DPC-NE-2005P-A

**DUKE POWER COMPANY
THERMAL-HYDRAULIC
STATISTICAL CORE
DESIGN METHODOLOGY**

SUBJECT: ACCEPTANCE FOR REFERENCING OF THE MODIFIED LICENSING TOPICAL REPORT, DPC-NE-2005P, "THERMAL-HYDRAULIC STATISTICAL CORE DESIGN METHODOLOGY" (TAC NO. M85181)

SAFETY EVALUATION BY THE OFFICE OF NUCLEAR REACTOR REGULATION
RELATING TO THERMAL-HYDRAULIC STATISTICAL CORE DESIGN METHODOLOGY

REVISED SCD FLOWCHART

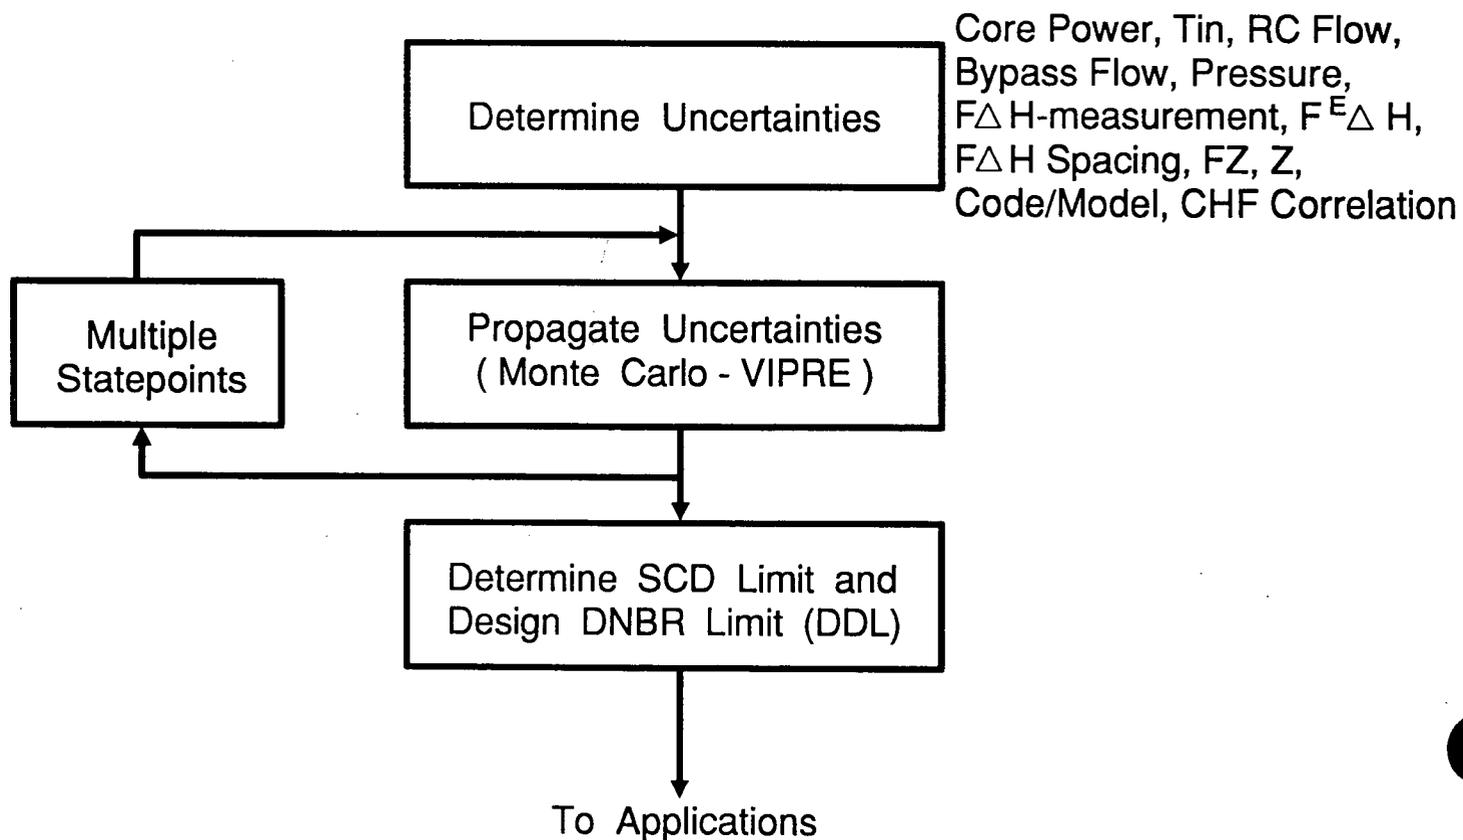
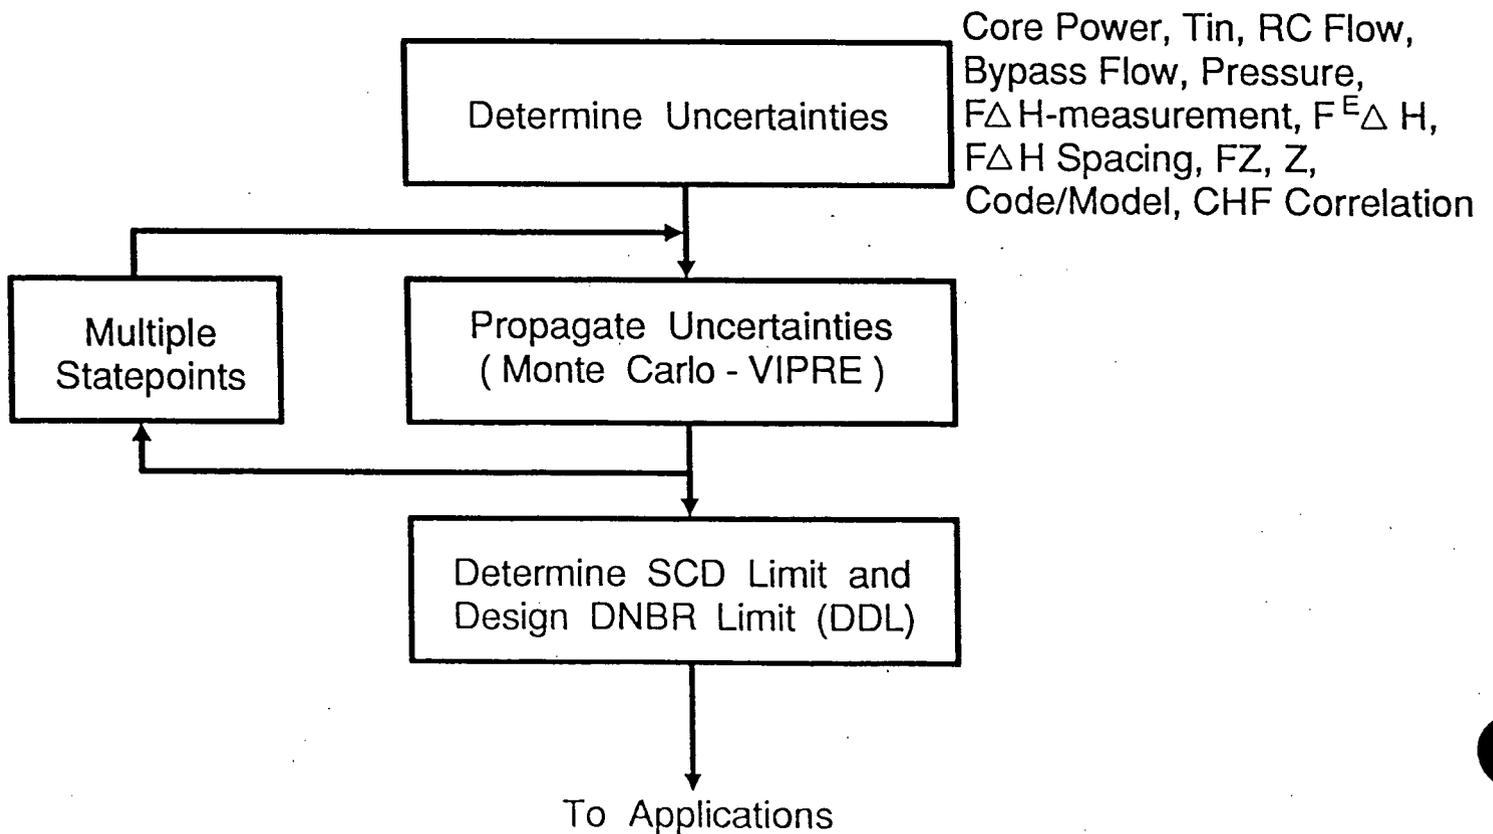
Additionally, the flow chart in Figure 2 also contains a typo. The Propagate Uncertainties box should have the words (Monte Carlo - VIPRE) underneath. The RSM is not used at all in the revised method described by the report. A corrected page 30 is also included.

REVISED SCD FLOWCHART
